PC0003/23 Farm Rd. ADC Comments on DO Ltd Stormwater RFI Response

The following stormwater matters need to be resolved as part of the plan change application if the Applicant intends the stormwater discharges to be authorised by ADC's global stormwater consent CRC186263.

Figure 1- K37/2568: less than 200m north of the site. 3m to gravels

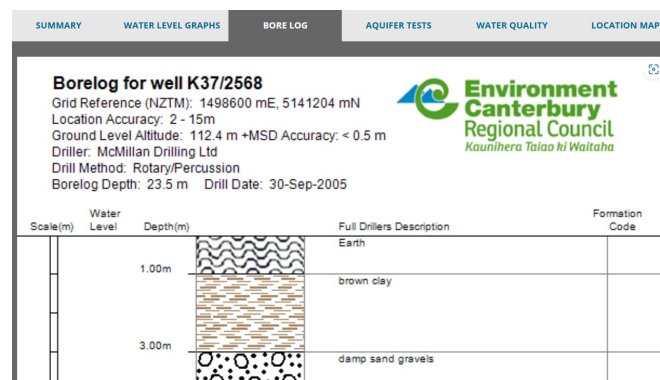
The depth to free draining gravel varies as shown of the following two nearby bore logs.

Based on bore logs, your comment and the test pitting/infiltration tests of 2023 we conclude that the free draining layer is between 1.5m and 3m below existing ground level across the site, rather than the assumed depth of 1.5m. This means that the excavation to free draining gravels for the infiltration systems will need to be deeper than 1.5m below existing ground to match.
